**ITEM 4.1: Design Review Permit – 1623 Santa Clara Drive – INFILL PCL 192 – Roseville Periodental Clinic – File #PL21-0315**

**REQUEST**

The applicant requests approval of a Design Review Permit, an Administrative Permit for a Parking Reduction, and a Tree Permit to allow the development of a 9,100-square-foot periodontal / dental building with associated parking, lighting, and landscaping improvements.

**Figure 3. Proposed Site Plan**

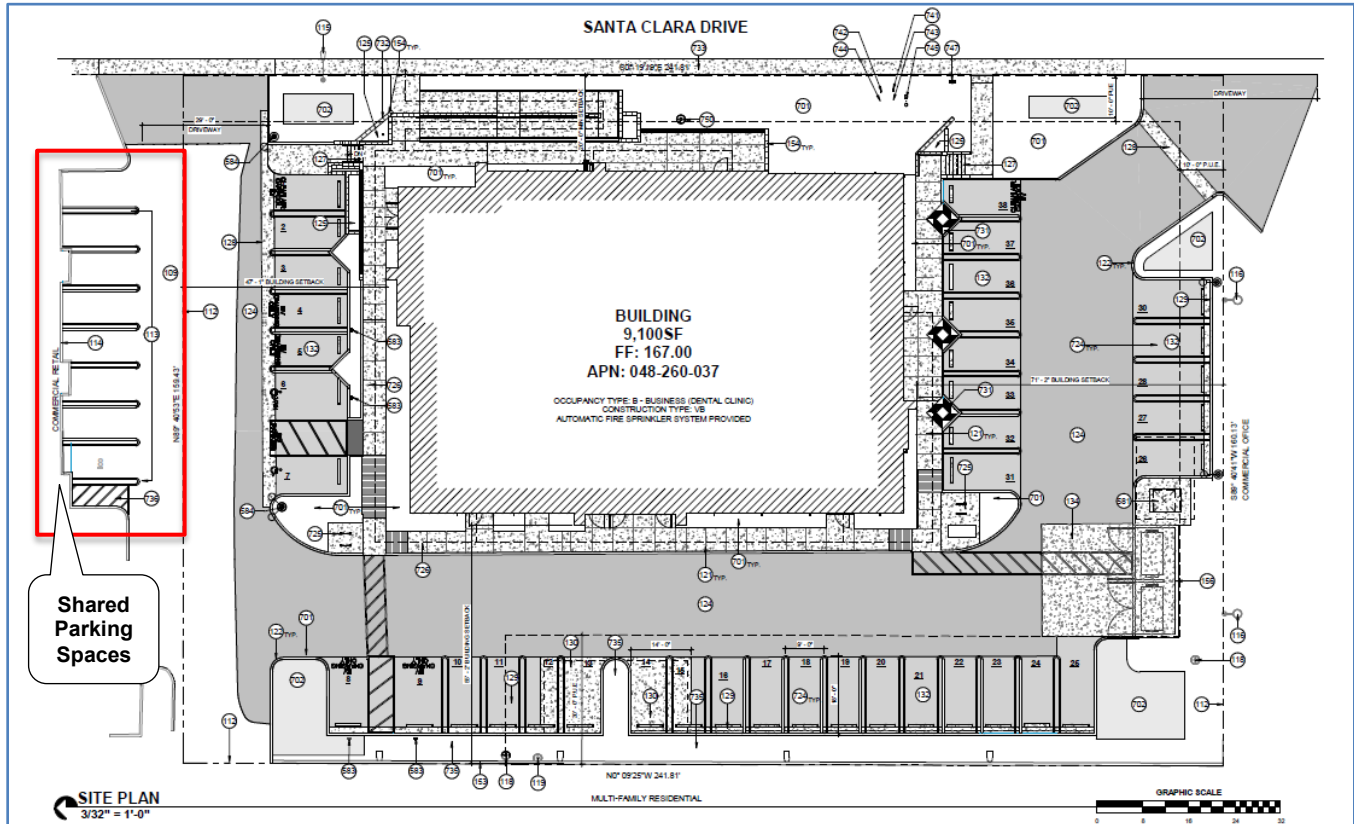
**Site Planning and Building Siting:** The location of buildings on the project site is constrained by several easements that exist on-site: a 20-foot ingress/egress easement along the northern property line, a 30-foot public utility easement along the western property line, and a 20-foot public utility easement along the southern property line. In addition, a 20-foot landscape setback is required along Santa Clara Drive. The main entrance to the building will be located on the north elevation, and parking will be provided north, west and south of the building. A low masonry wall and an ADA-accessible ramp will face Santa Clara Drive. A masonry wall will also be installed along the western property line to provide sound attenuation between the proposed project and the existing apartments to the west. This wall will be approximately 6 to-8 feet tall as the height varies and follows the natural grade of the property along the western property line. The wall has been designed to provide a minimum height of 6 feet when measured from the parking field of the project.
